Affected Models:
All Emira Models

Number:
131-26009

Availability of ASO exhaust muffler (rear silencer) valve actuator as service replacement part.

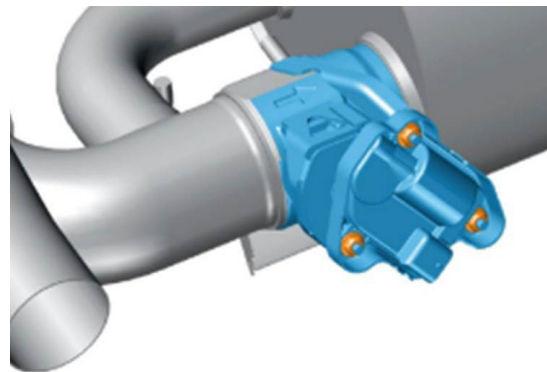
Until recently the failure of the exhaust muffler valve actuator has required the exhaust muffler and valve to be renewed as a complete assembly.

The exhaust muffler valve actuator is now available as a separate replacement part. The advantages of not having to replace the combined assembly are for a faulty actuator are:

- Less labour-intensive procedure to replace.
- More practical to keep an exhaust muffler valve actuator as a parts stock item.

If an exhaust muffler valve actuator is diagnosed as faulty then please determine if the exhaust flow valve mechanism in the rear silencer is operating and moving correctly*, if it is then please fit a new valve actuator instead of a complete muffler assembly.

*Actuator replacement is only suitable if the exhaust flow valve mechanism in the rear silencer is operating and moving correctly. If the exhaust flow valve is not operating or seized, then the exhaust silencer or actuator assembly should be replaced.
